ORDINANCE NUMBER 2016-09

AN ORDINANCE OF THE TOWN OF PARADISE VALLEY,
ARIZONA AMENDING THE PARADISE VALLEY ZONING
ORDINANCE, Article XXII, HILLSIDE DEVELOPMENT
REGULATIONS

December 5, 2017 Draft Wastchak//Strom Draft

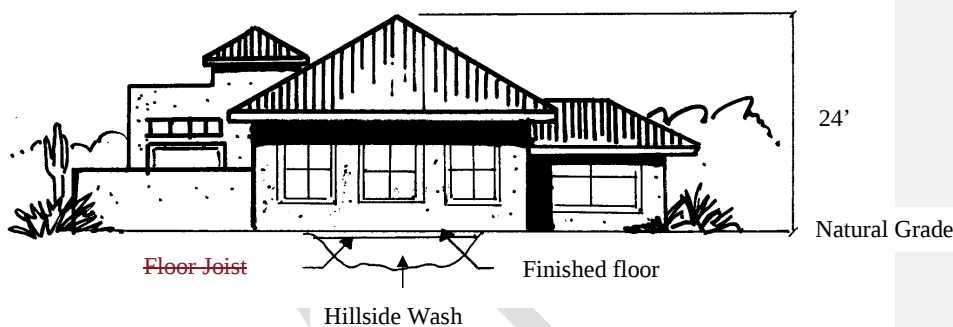
I CAN'T EDIT FIGURE 6. DELETE "FLOOR JOIST". IT ADDS NOTHING AND MOST LIKELY THE FLOOR WILL BE CONCRETE SLAB OR THE JOIST WILL BE COVERED WITH INSULATION AND NOT VISIBLE

Commented [PL4]: Remove floor joist arrow from staff version

FIGURE 7 - HEIGHT FOR A CANTILEVERED ELEMENT

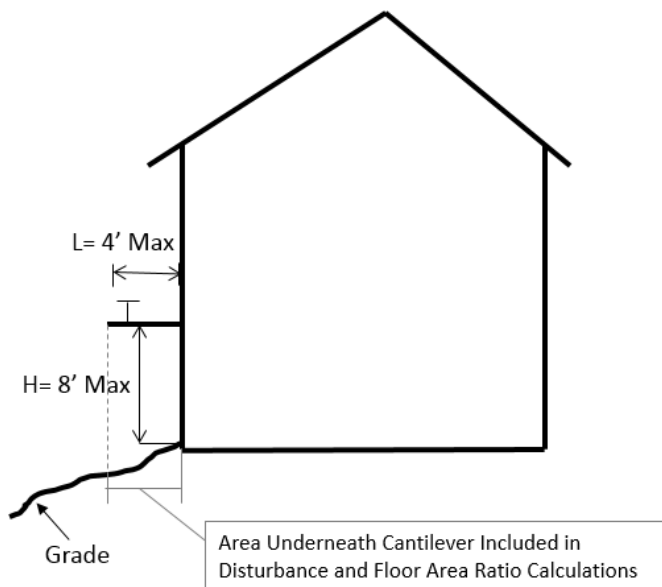
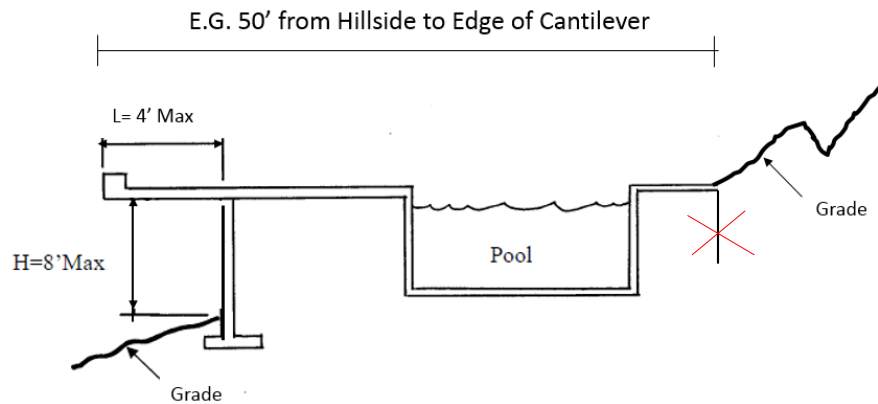
DELETE THE VERTICAL LINE ON THE RIGHT SIDE OF THE FIGURE. DON'T KNOW WHAT IT MEANS
